FREDERICK COUNTY PLANNING COMMISSION
August 12, 2020

TITLE: Hyattstown Business Park Expansion

FILE NUMBER: SP257739 (SP88-41), APFO #A258763,
FRO #F257746

REQUEST: **Site Development Plan Approval**
The Applicant is requesting Site Plan approval to expand the two existing buildings and construct associated improvements to the loading and parking areas.

EXHIBIT A
Grading Exhibit Demonstrating Extent Required if Truck Route is Eliminated
Approximate Scale: 1"=50'

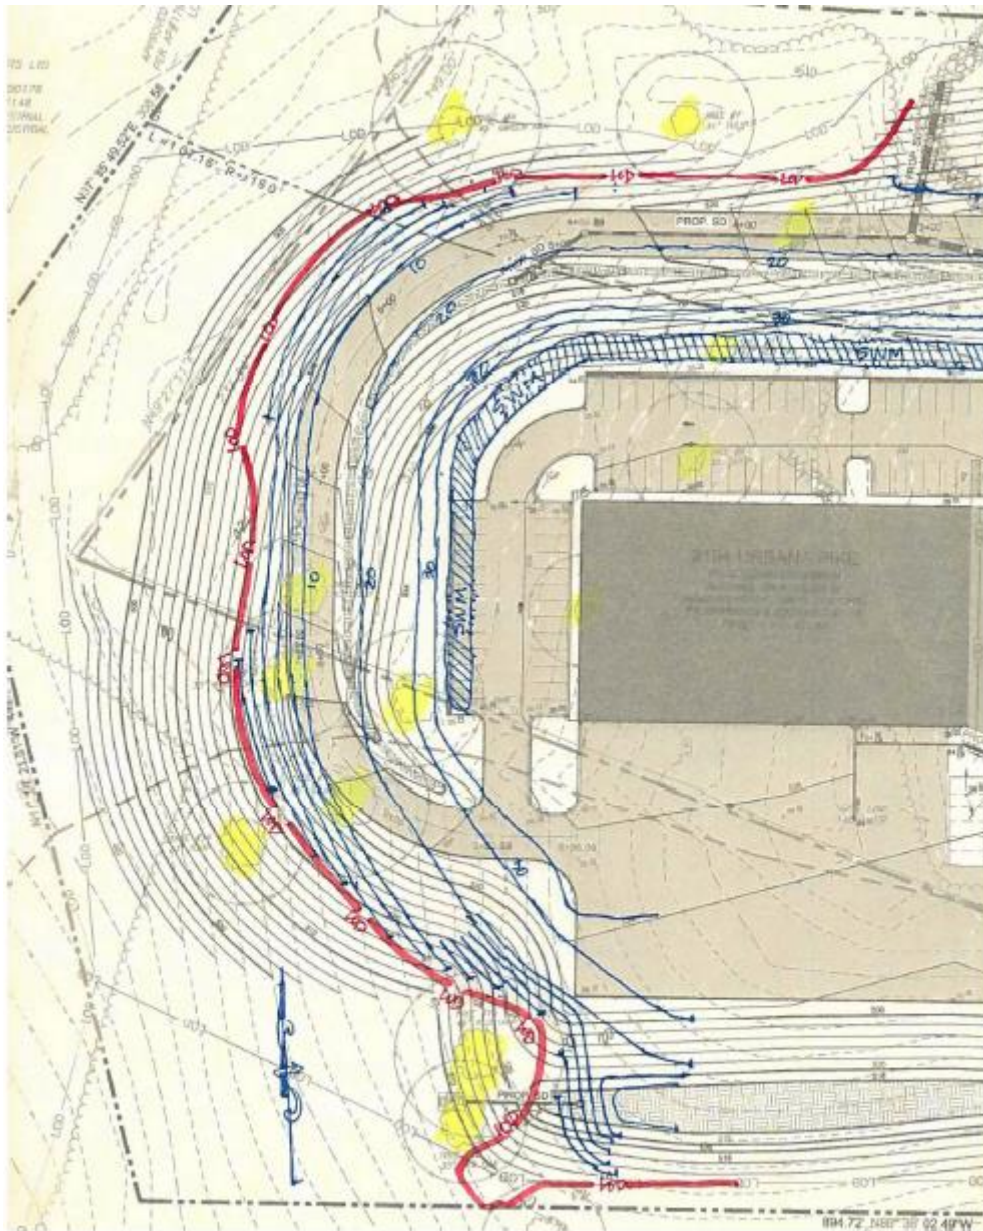
Analysis of alternative truck route layout and grading plan Refer to Exhibit A

In an effort to examine an alternate layout for the western end of the proposed expansion, specifically the reconfiguration of the proposed truck route and elimination of a bay of parking spaces, to determine if there is potential to preserve specimen trees originally proposed for removal. The alternative layout, although highly undesirable by the current tenant due to the conflict between passenger vehicles and tractor trailers and the reduced maneuverability of larger vehicles through the parking lot, would direct the truck traffic through the parking lot and allow access to the rear loading area.

The exhibit eliminates the segregated truck route and one bay of thirteen (13) parking spaces. With the removal of the truck route, the stormwater management (SWM) facility that is proposed on the inside of the route would need to be relocated uphill, just behind the outermost fringe of the parking lot and will require a relatively flat terrace to facilitate the required SWM facility grading. Just past the SWM facility, the slope is graded down and out at a 3:1 slope, just as in the original layout. With this alternative layout, the grading extent encroaches through trees #9A, #11, #13 as the as in the original layout and impact the CRZ of tree #14. The grading places 3' to 7' of fill at the trunk locations and the depth of fill increases significantly as the slope increases in elevation uphill (to the east). The examination of the alternate demonstrates that three (3) of the four (4) trees that are proposed for removal are also removed with this layout, therefore, retaining the proposed truck route is sought as it maintains the desired intent of keeping truck traffic separated from passenger car parking and circulation. The possibility of incorporating retaining walls is discussed below.

As part of the analysis, it was determined that four (4) trees #4, #7 #9B and #10 can be preserved. The proposed grading off of the north east radius of the truck route was refined and Trees #4 and #7, located in the reservation area, will be preserved. These trees will require impacts (less than 30%) to the uphill sides of the CRZ's to allow for fill for the proposed grade to tie out to existing. In addition, the loading area off of the south west corner of the building #2194 expansion was reduced to allow for grading refinement, this along with the reconfiguration the SWM facility and outfall location allows for the preservation of Trees #9B and #10. Here too, these trees will require impacts (less than 30%) to the uphill sides of the CRZ's.

EXHIBIT B
 Wall Exhibit Demonstrating Extent and Height of Retaining Walls if Truck Route is Eliminated
 Approximate Scale: 1"=50'

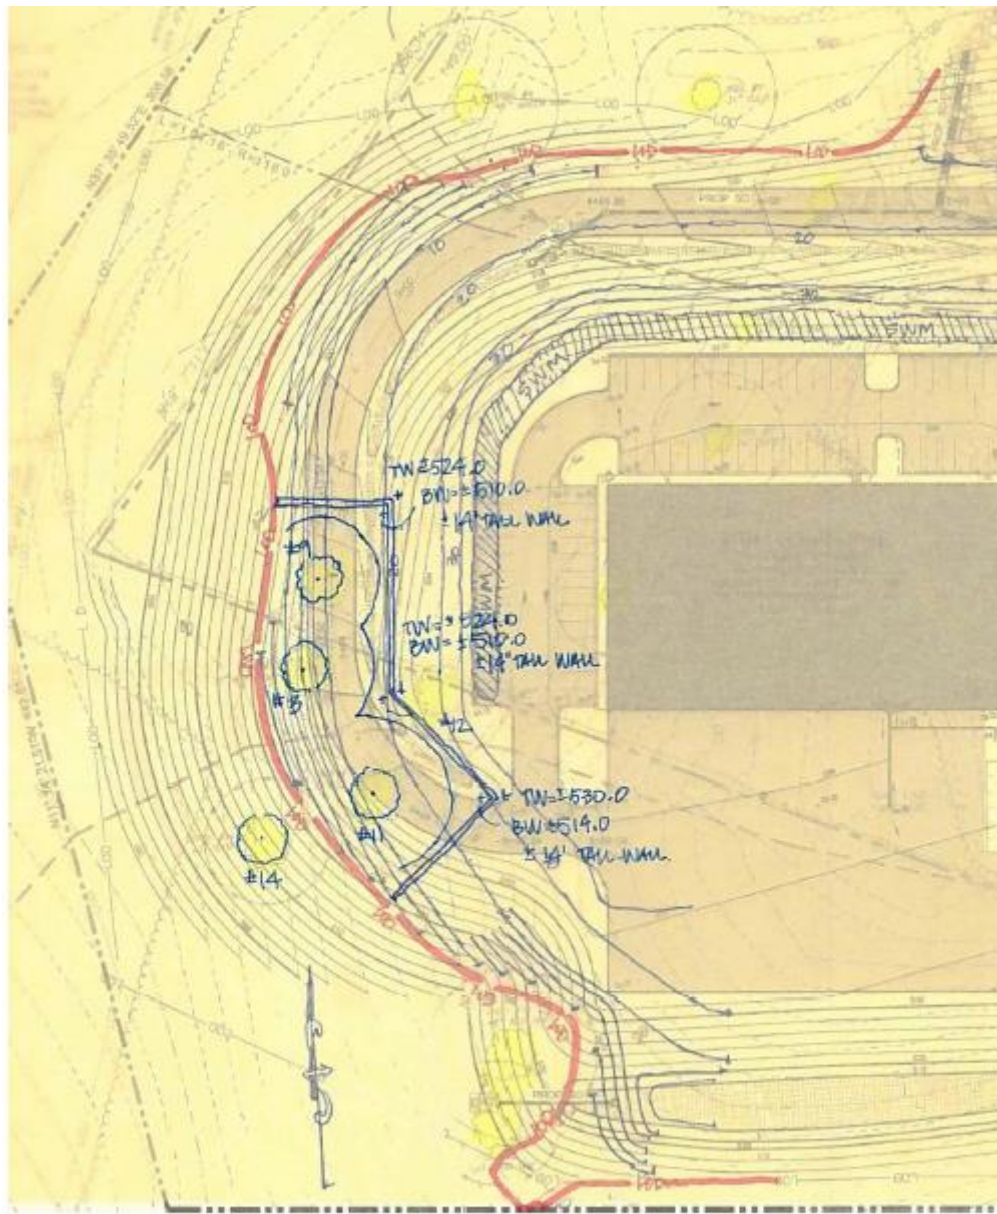
Analysis of retaining walls to preserve the CRZ of trees #9A, #11, #13 and #14 Refer to Exhibit B

Examination of the possibility of providing retaining walls around the CRZ of trees #9A, #11, #13 and #14 concludes that a wall totaling approximately 300 linear feet and measuring 14' tall for 160' of that length. The other two wings of the wall would be approximately 80' and 60' and will vary in height from 14' to 0' as these walls would follow the tie out grading downhill. Considering these dimensions in addition to the necessary 3' depth to footer along the entire length, the approximate square feet of total wall face is estimated at 4,100 SF at a cost of \$40 per SF, plus railing at \$50 per LF and footer at \$100 per LF the approximate cost this wall would be \$210,000. This is a substantial cost for the preservation of four (4) trees especially if there are existing un-observable issues / conditions with trees or other potential natural issues such as insect infestation, disease, wind damage or lightning. All too often, there is a good intent in extensive and costly measures to preserve trees, that unfortunately end up being all for not due to unforeseen events or circumstances.
